**RE: Tierra Robles EIR**

## Response to Letter 9 – Public Interest Law Project

Subject: Draft Environmental Impact Report for Tierra Robles Planned Development, SC# 2012102051

## Response to Letter 11 –California Oaks

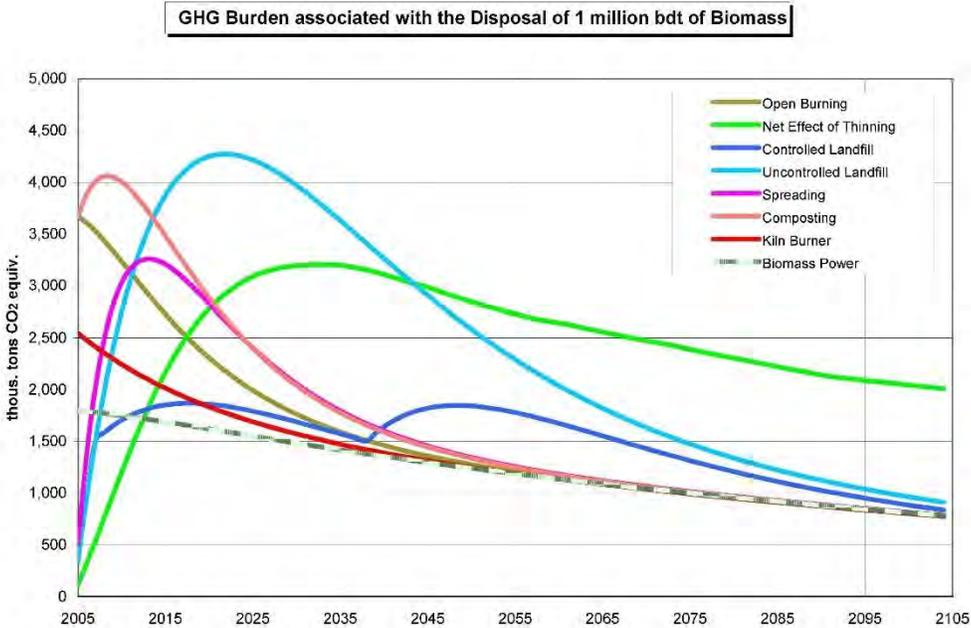
The following chart illustrates the relative GHG indirect biogenic emission effects from common methods of vegetation (biomass) disposal.<sup>1</sup> **The biomass combustion GHG emission values do not include black carbon emissions.**

Uncontrolled landfill disposal produces the greatest biomass GHG biogenic emissions followed by composting, open burning, mulching, forest thinning, kiln burner, controlled landfill and biomass power. The chart demonstrates that peak GHG emissions vary substantially depending on the means of biomass disposal, with the higher peaks reflecting increased amounts of methane and/or nitrous oxide emissions.

Terminology: Net effect of thinning emissions apply to forest thinning emissions and spreading emissions are equivalent to mulching emissions.

11-i

**Response 11-i:** The commenter provides Attachment A to the letter providing additional biomass disposal GHG emissions information.

Refer to **Response 11-e**, above. As stated above, the accumulation of carbon in biomass slows with age and increases in biomass carbon are assumed to be offset by losses from pruning and mortality. As such, the potential loss of carbon stock associated with the removal of trees and vegetation is considered carbon neutral in the long term given that trees and vegetation would release the carbon when they die and decompose. Additionally, although 446.6 acres of oak woodlands would be impacted by the project, only 146.2 acres will be converted to residential uses. The additional 300.4 acres would be fragmented by the proposed lots and oak trees outside the proposed building envelope would remain. Therefore, the project would not represent a total land use conversion. Mitigation includes permanent conservation easements being established, as well as the planting of 137.8 acres of new blue oak woodland. The new oak trees would likely be planted more closely together than the original oak trees in the existing woodland, leading to greater sequestration potential using less land.
